Drawing Title
LOT F1 - LEVEL 01 - FLOOR PLAN

PROJECT NAME
DRURY TOWN CENTRE - FAST TRACK STAGE 2

Project No.
0460-119

Drawing No.
H2-1301

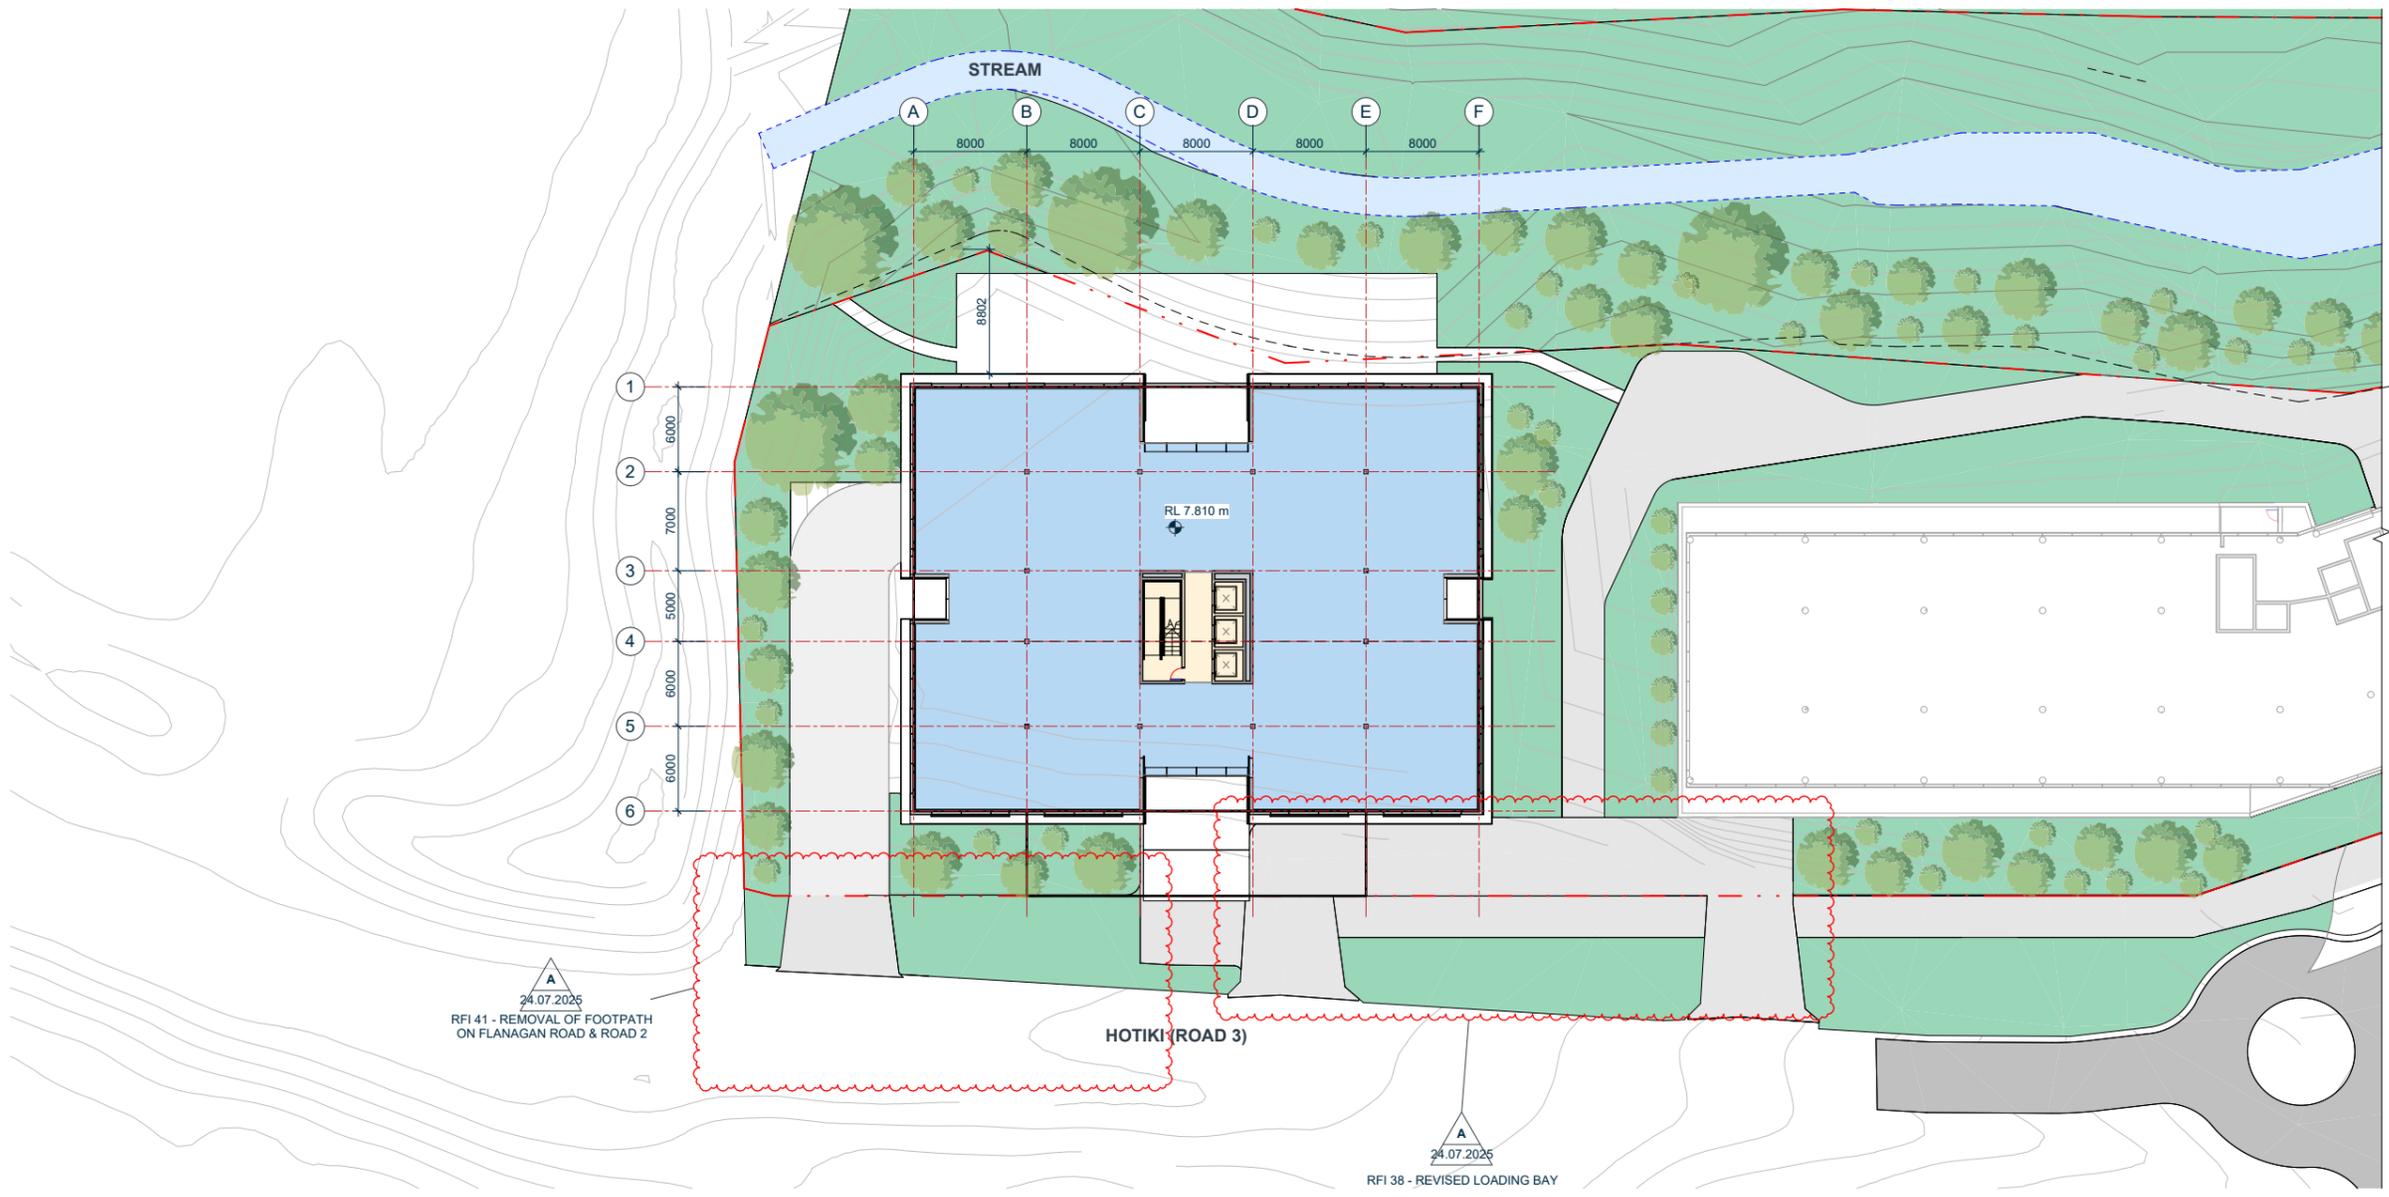
A
 24.07.2025
 RFI 41 - REMOVAL OF FOOTPATH
 ON FLANAGAN ROAD & ROAD 2

Drawing No.
H2-1302

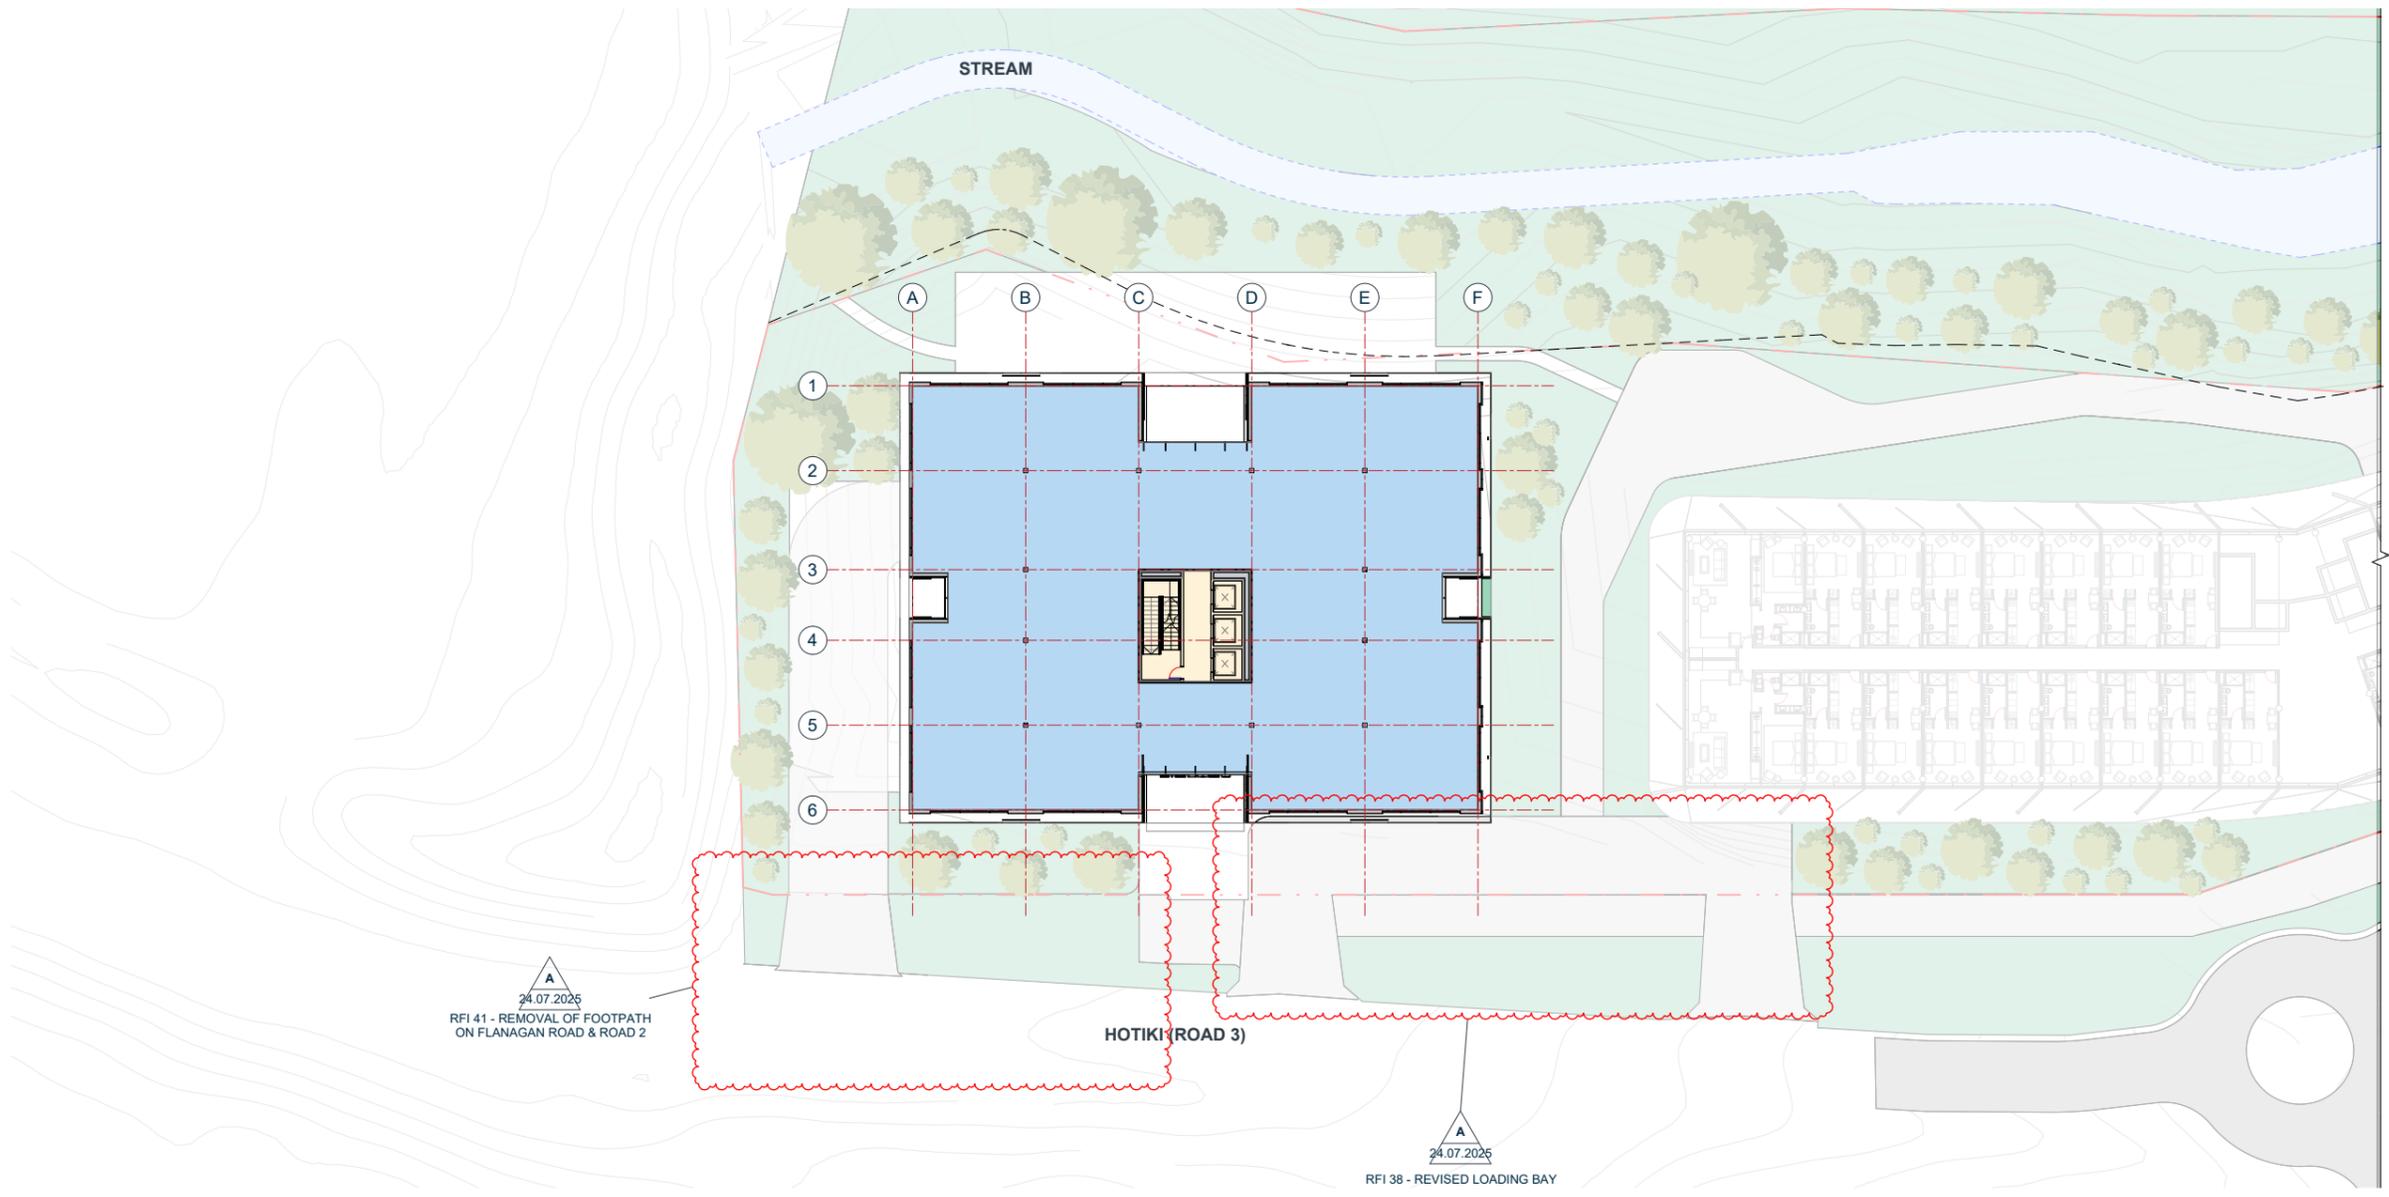
A
24.07.2025
RFI 41 - REMOVAL OF FOOTPATH
ON FLANAGAN ROAD & ROAD 2

A
24.07.2025
RFI 36 - REVISED LOADING BAY
